CITY OF BLOOMINGTON

PLAN COMMISSION

September 11, 2023 5:30 p.m.

**BLOOMINGTON PLAN COMMISSION
STAFF REPORT
Location: S. Weimer Road**

Image One August

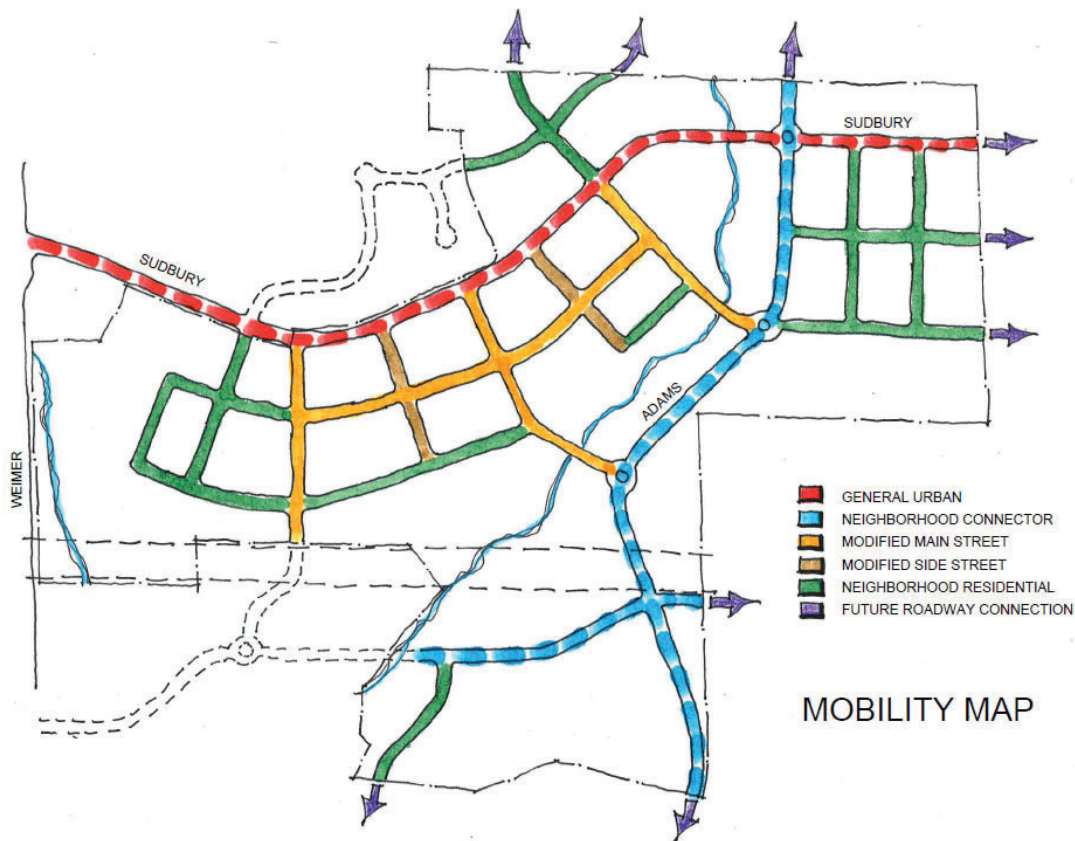
The image below indicates that the roadway configuration has changed since July, with less roadways shown. All of the points of exit from the site have been maintained with three added to the east and one to the north.

1. The southernmost connection in the Transportation Plan raises questions.
 - a. The petitioner is proposing a trail connection to Weimer Road. In consultation with the Parks and Recreation Department, the petitioner may be asked to build the entirety of that trail on their property, bypassing the property to the southwest.

2. The proposal is not more gridded than the July version, but does provide additional external connections.
3. Same question from July: Adams Street to the north is privately maintained in the County. Have discussions been had with that entity?

4. A stub to the east is provided.
5. Same question from July: When the property is subdivided, platting and construction of the roads in the Transportation Plan will be triggered. The expectation is that they are built within the time allowed by the UDO, which is a matter of a few years. Does phasing for the roads need to be included in the PUD separate from the neighborhoods?

Image Three

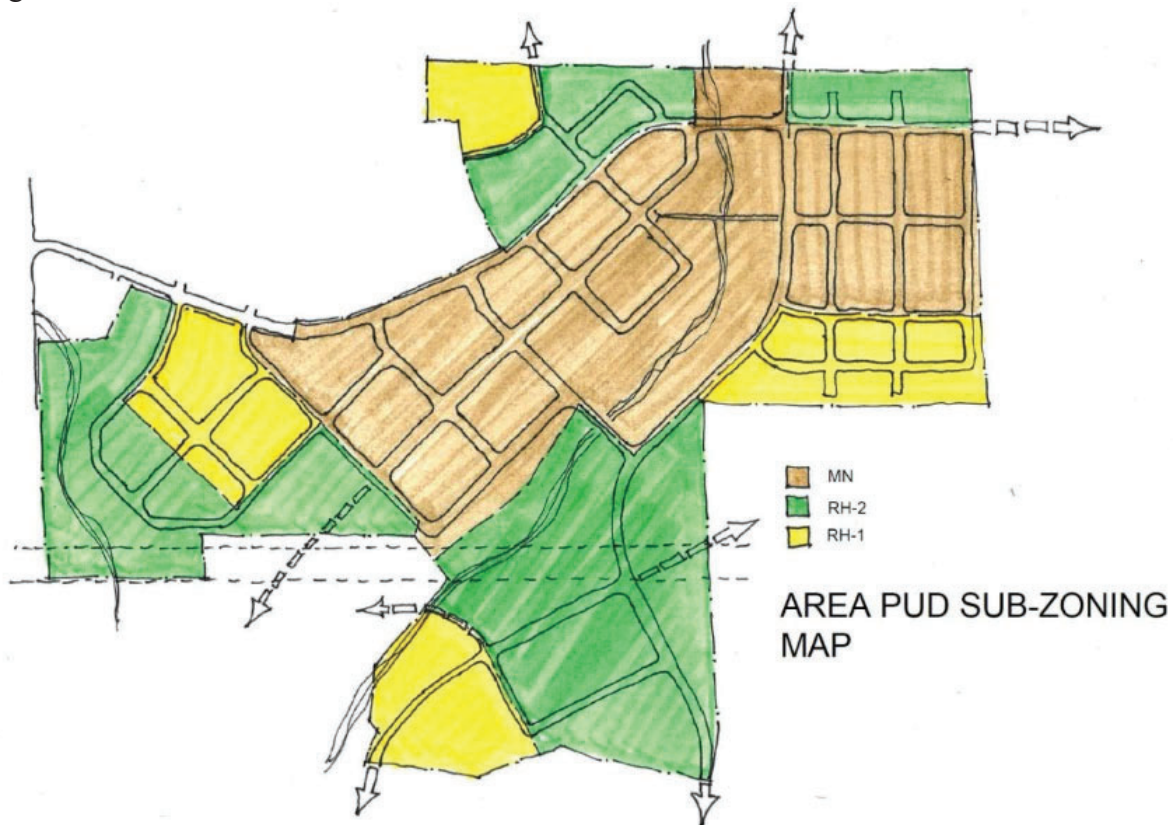
1. In a typical zoning code, each district has a set of development standards AND a set of allowed uses. Those standards and uses apply to the entirety of the district, unless the Dimensional Standards Table or Use Table is augmented by Use-Specific Standards. The petitioner is proposing that allowed uses be regulated by separate spatial areas, meaning that while all MN areas have the same development standards, they do not all have the same allowed uses. The uses need to be uniform in each of district, but can be augmented by Use-Specific Standards. The petitioner is working toward this goal.

2. In most PUDs, petitioners identify those standards that do not meet the Unified Development Ordinance. Per 20.06.070(c)(5)(B), "to the extent permitted by Section 20.01.040(b) (Effect of Change in the Law after Filing of Complete Petition), changes to the UDO that alter any development standards for which the PUD district ordinance is silent shall apply to portions of the PUD for which an approved site plan has not been approved before the date of the UDO change." The petitioner has included many regulations from the UDO verbatim in their district ordinance, in order to 'freeze' those regulations in time. While the Department is sympathetic to the desire to have total control over the design of future development, we think that the amount of things currently included that are verbatim from the UDO is excessive, and also creates confusion about which regulations are actually different. We would like to see the duplication of the UDO drastically reduced. Not only because it creates confusion about which regulations are proposed to be changed, but also because it may create confusion about which aspects the PUD is silent on, and revert to the UDO, as described in the reference above. For example,

if the petitioner only submits a list of amended Primary Materials with no mention of Secondary Materials, as they have done in this instance, are they expecting no Secondary Materials? Or are they expecting the Secondary Materials from the UDO? If there is a section in the UDO with 7 subsections, and the petitioner submits 2 amended and only 2 additional, are the other 3 moot? Or do they revert to the UDO? The style that is in the current draft will not work long-term, and needs to be amended. The best way to do this is to remove large amounts of the verbatim language.

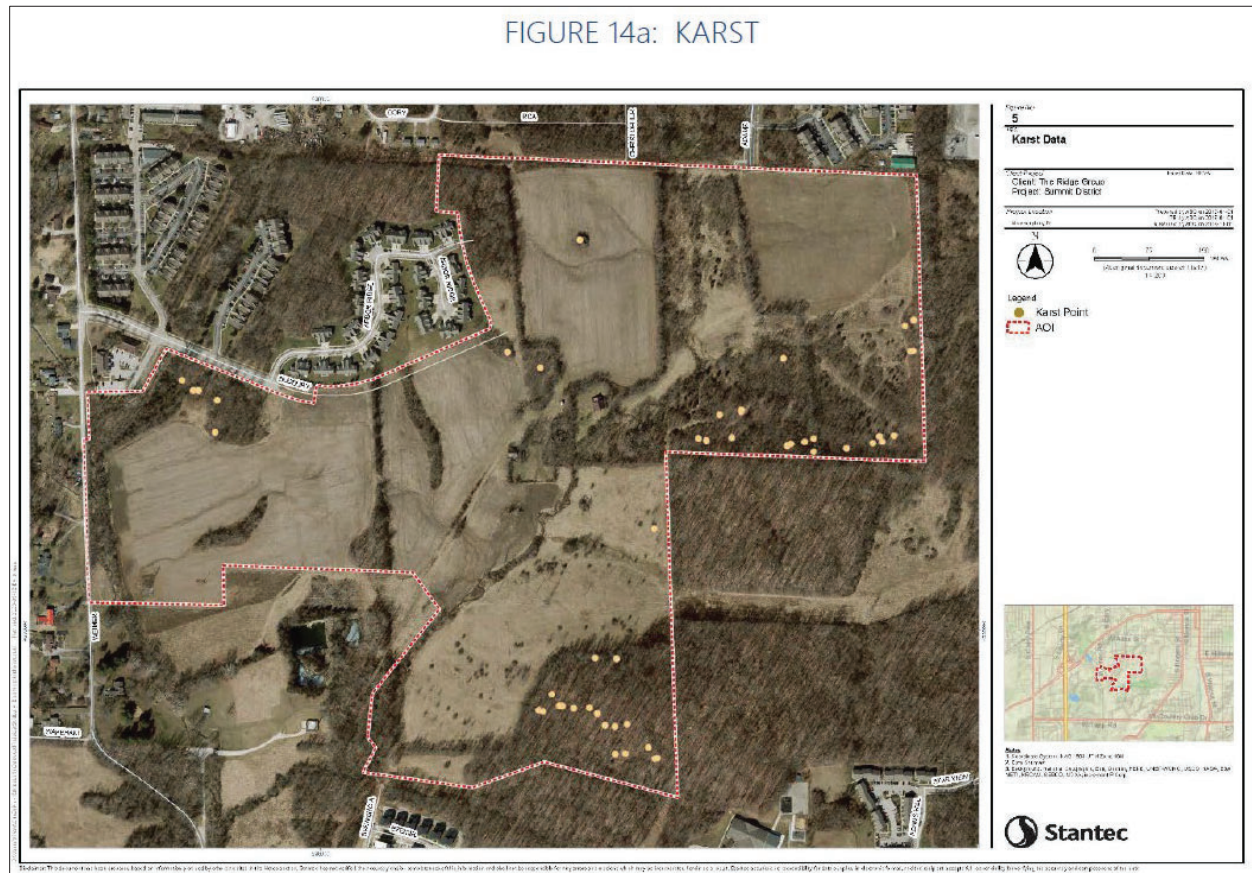
In regard to karst features, the Petitioner (Sudbury Development Partners, LLC) provided a map, “establishing specific environmental site features” (FIGURE 14a: KARST) in its Preliminary Plan. FIGURE 14a: KARST can be found on Page 159 of the meeting packet of the July 10 Plan Commission meeting. See screenshot below for the map provided by the Petitioner.

One can easily count approximately a total of 45 to 48 yellow dots (some adjacent to each other) representing karst features dotted all around the Summit District PUD, with several of them being in very close proximity to each other. It is unclear whether these karsts are surface, subterranean (surface) or compound. A quick search in the PDF did not produce any further explanation from the Petitioner. The Petitioner did not request exceptions on karst, so the Unified Development Ordinance (UDO) of the City of Bloomington applies.

Figure 2. Proposed Weimer Retention Pond on Shasta Hillside¹

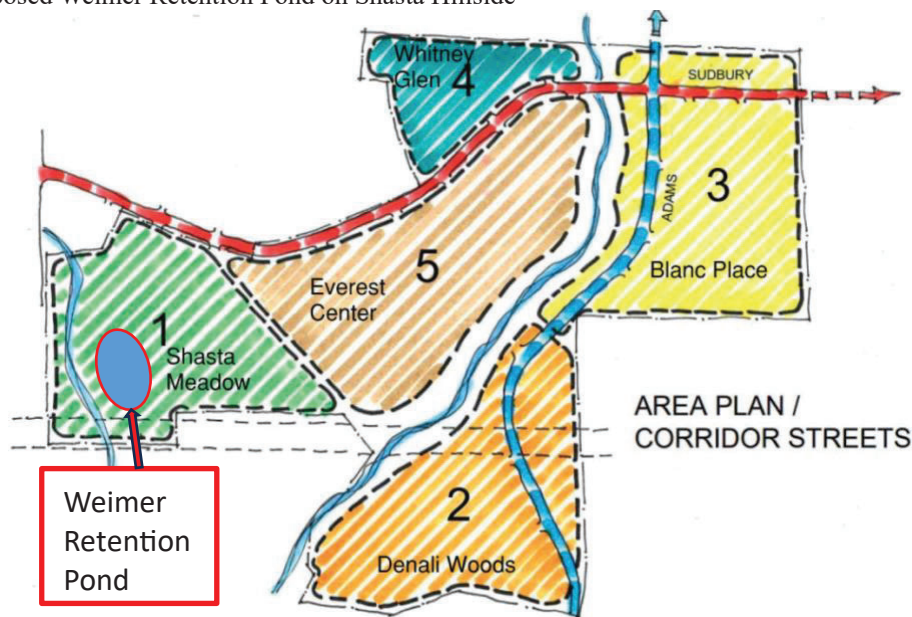
A Proposal: Weimer Retention Pond (Figure 2)

One way to do this would be to build a storm-water retention pond along the bottom of the western hillside but above Clear Creek as part of the proposed Summit District PUD. Engineers would be able to figure out how big the pond should be, given the severe slope and the increased run-off from impermeable surfaces to be added in the development.

If designed carefully, the retention pond should *decrease* the amount of flooding along the Weimer-Road-Clear-Creek flood plain. If the Summit District PUD does provide this retention pond, it could actually reduce the overall flooding that currently occurs after heavy rainstorms. Instead of making the flooding problem worse, it could help decrease the flooding along Clear Creek and Weimer Road after heavy rains.
